UNITED STATES PATENT AND TRADEMARK OFFICE

APPLICATION NO.	FILING DATE	FIRST NAMED INVENTOR	ATTORNEY DOCKET NO.	CONFIRMATION NO.
09/802,982	03/12/2001	Stefan Karl	1200.473	6932

Office Action Summary	Application No.	Applicant(s)	
	09/802,982	Karl	
	Examiner	Art Unit	
	Ford	3743

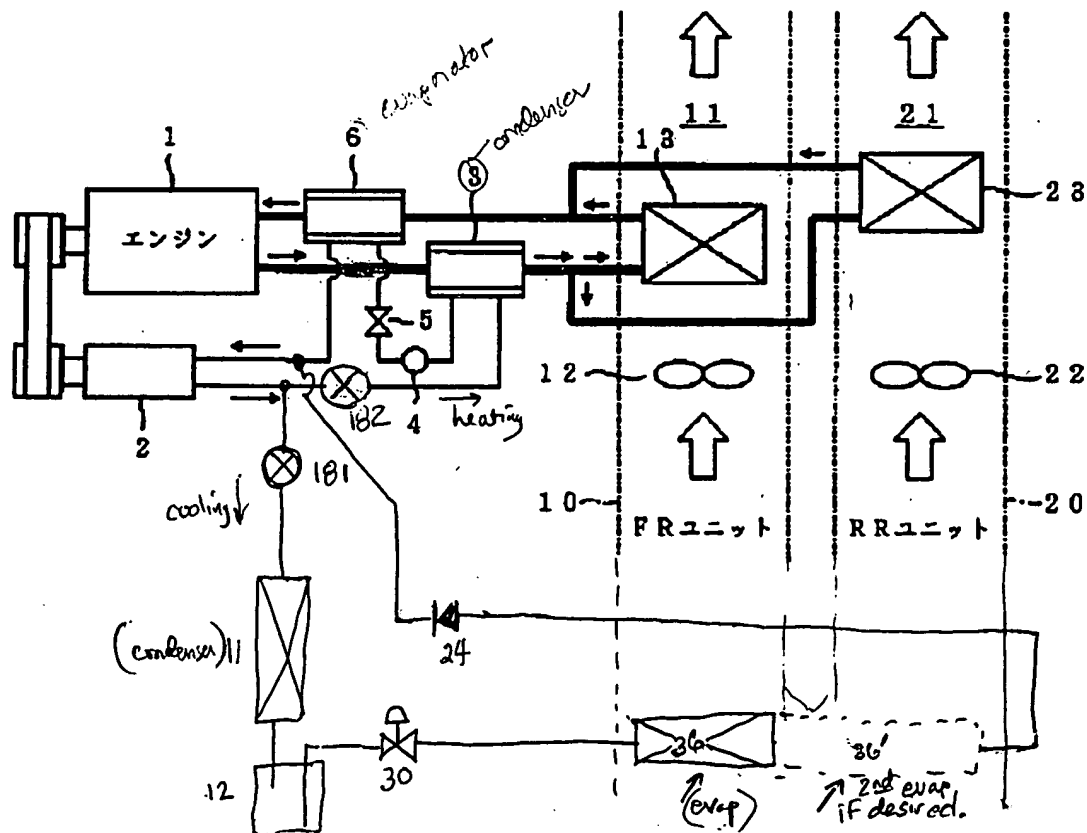
Claims 1, 2, 10, 11, 13 and 14 are rejected under 35 U.S.C. 103(a) as being unpatentable over JA 10-76837 in view of Enomoto Figure 8, and the description thereof.

JA '837 shows a refrigerant system for beneficially increasing the heating effect of a liquid based heating system. It has no ability to cool the compartment in hot weather. The compressor 2 is known to be the most costly component of automotive refrigerant systems.

Enomoto teaches in Figure 8 a refrigerant based heater circuit (182, 13, 37, 15~~6~~) and a refrigerant based cooler circuit (181, 11, 12, 30, 36 and 24) connected in parallel across the output and inputs of the compressor 10.

To have added a refrigerant based cooler circuit (as described above) to JA '837 to give the capability of cooling in the summer as well as heating in the winter would have been obvious to one of ordinary skill in climates ^{where} ~~were~~ air conditioning was needed to preserve occupant comfort. Appropriate valves (181, 182) on the discharge side of the compressor would be necessary to separately activate the heating and cooling systems. The modification is shown below.

Regarding claim 10, see element 24 in the sketch. Regarding claim 11, see elements 5 and 30.
